**AGENDA
TECHNICAL REVIEW COMMITTEE (TRC)
May 6, 2025
10:00AM**

**MINUTES
TECHNICAL REVIEW COMMITTEE (TRC)
April 1, 2025
10:00AM**

**RE: SWC-23 AMERICAN AUTO RV & BOAT STORAGE (AVO 043866.157)
MAJOR SITE PLAN REVIEW #2**

**RE: GRIFFIN PRESERVE PRELIMINARY PLAT (AVO 043866.154)
REVIEW #2**

C-04

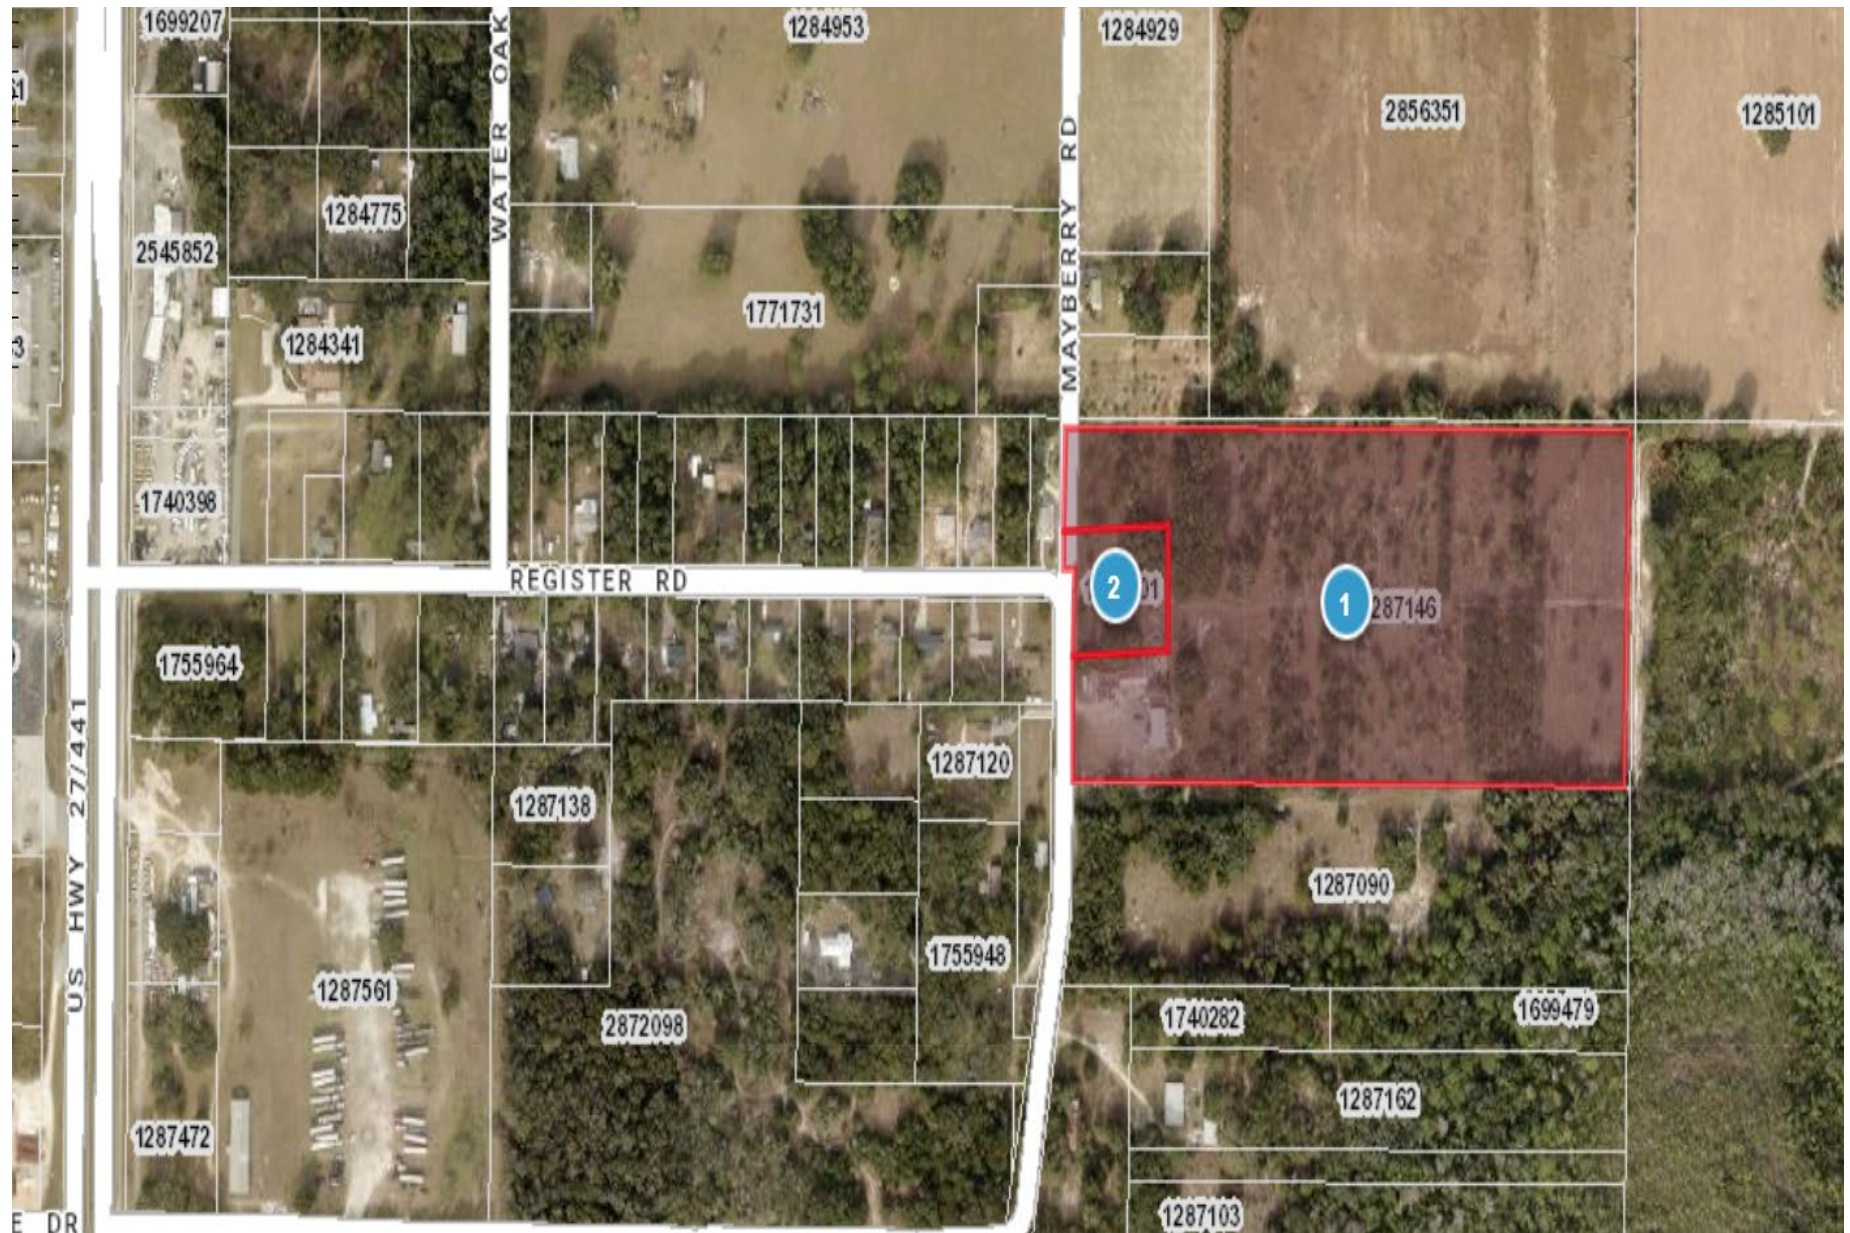
Pursuant to Section 162.080(a)(1)(F) sidewalks are required in adjacent right of ways and none are shown adjacent to American Lane. The applicant indicates that they are requesting a variance from this requirement. The applicant will need to modify the application to include the variance along with the appropriate filing fee and submit additional information to meet the requirements of Chapter 168, Section 168.010(C)(3) and (f).

Pursuant to Section 162.090(b) and (c) right of way for local roadway is 50' and the note on the site plan indicates that the existing right of way width varies. American Way appears to be private roadway; additional right of way may be required in order to meet the LDRs. In addition, the existing roadway does not appear to meet the standard paving details of the City of Fruitland Park.

Pursuant to Chapter 159, Section 159.100(3) requires 1 dumpster pad for every 30,000 SF of warehouse space. Sheet C-04 indicates that the proposed warehouse space is 178,827 SF which would require 6 dumpster pads. The plans indicate 1 dumpster pad. The applicant indicates that they are requesting a variance from this requirement. The applicant will need to modify the application to include the variance along with the appropriate filing fee and submit additional information to meet the requirements of Chapter 168, Section 168.010(C)(3) and (f).

Please revise site plan and submit revised application and submit additional data in regards to the proposed variances as noted above.
